## Product Change Notification / JAON-17NPXF486

CCB 3280.003 Final Notice: Qualification of MTAI as new final test site for selected AT24C0xx, AT24C16x, AT24C32E, AT24C64B, AT24HC0xx, AT93C46x, and AT93C86A device families available in 8L PDIP package.

**CCB 3280.003**  
**Pre and Post Change Summary**  
**PCN# JAON-17NPXF486**

# Pre and Post Change Summary - Pin 1 Orientation

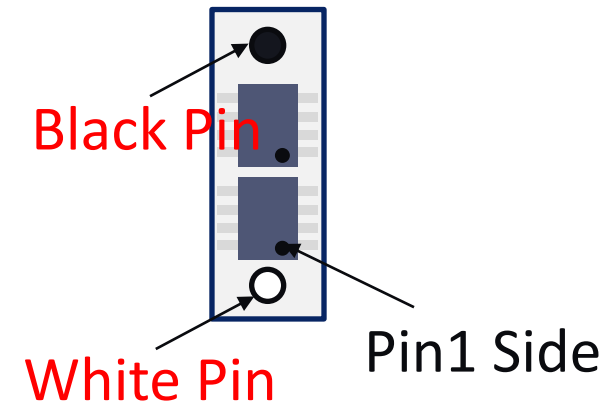
ANAP

MTAI

# Pre and Post Change Summary – Tube Drawing

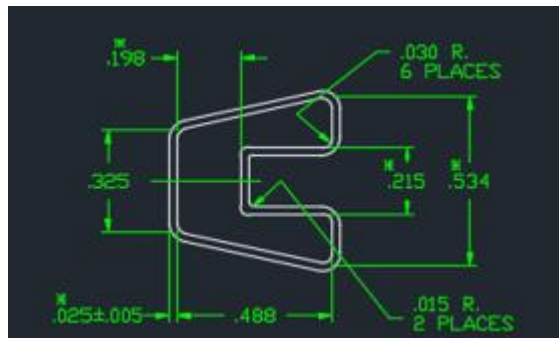
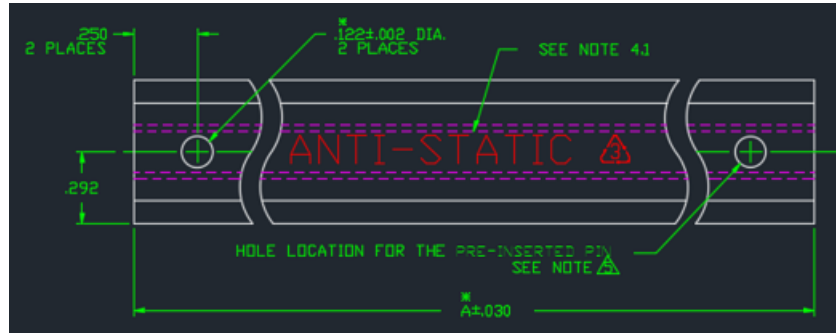
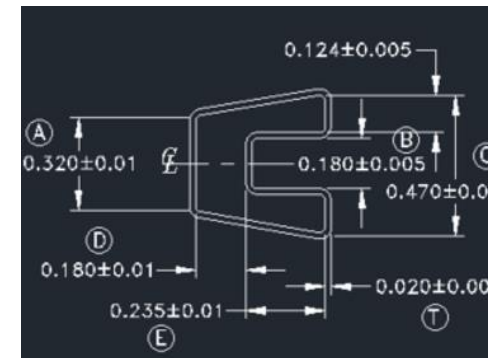
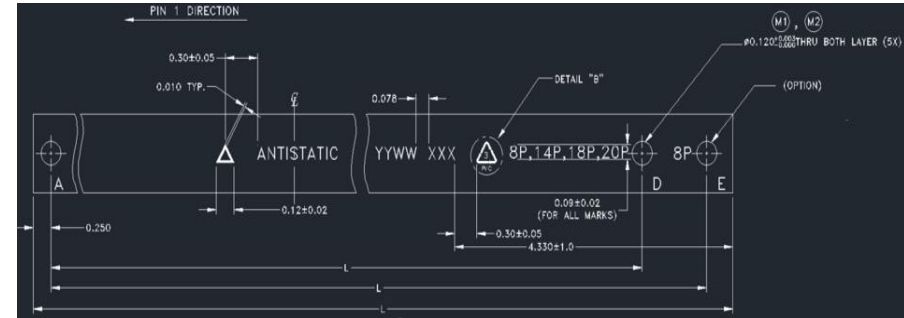
Plant	Tube Length (inch)	Center Hole A to Center Hole D (inch)	A (inch)	B (inch)	C (inch)	D (inch)	E (inch)	T (inch)	Color
ANAP	20.00 +/-0.030	19.50 +/- 0.030	0.325 +/- 0.010	0.215 +/-0.010	0.534 +/- 0.010	0.198 +/- 0.010	0.290 +/- 0.010	0.025 +/- 0.005	Transparent Clear
MTAI	20.33 +/-0.025	19.28 +/- 0.050	0.320 +/-0.010	0.180 +/-0.005	0.470 +/-0.010	0.180 +/-0.010	0.235 +/-0.010	0.020 +/-0.003	Transparent Clear
